## **Stage 1 Road Safety Audit**

**Strategic Housing Development at Bóthar An Choiste,  
Castlegar, Galway**

On behalf of Lock House Developments Ltd

**July 2022**

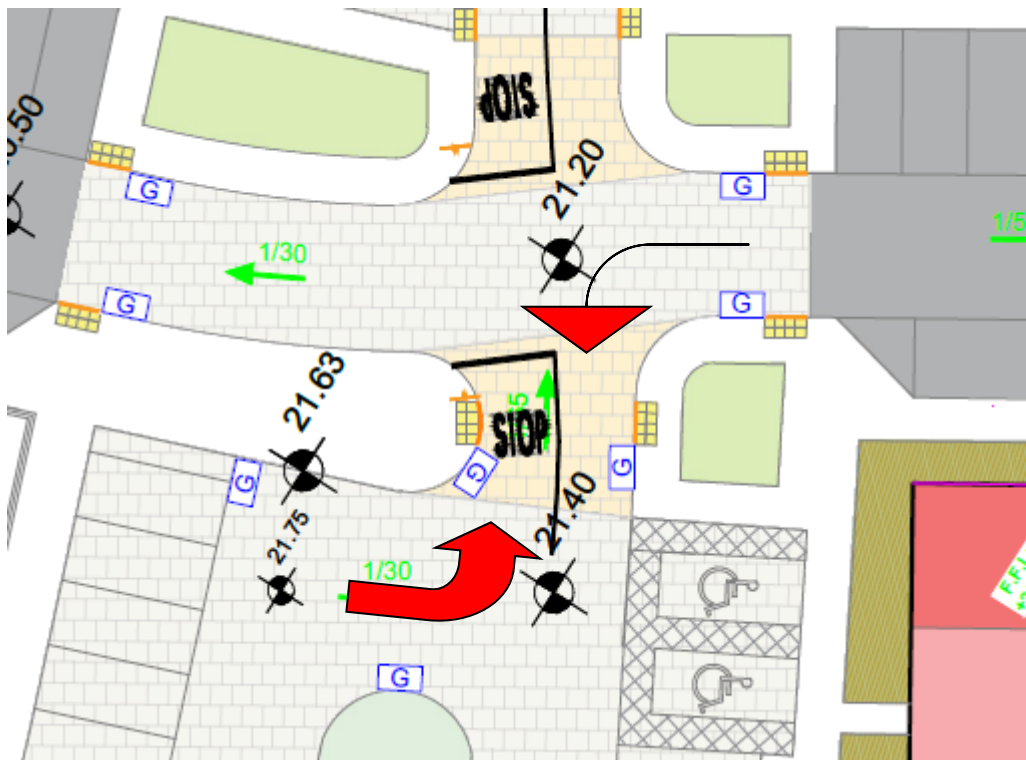
**Problem:** Parking may occur within the turning head of the north-eastern cul-de-sac.

**Hazard:** The bin wagon may be forced to reverse over a long distance and strike a pedestrian.

**Recommendation:** Ensure parking cannot occur in the turning heads.
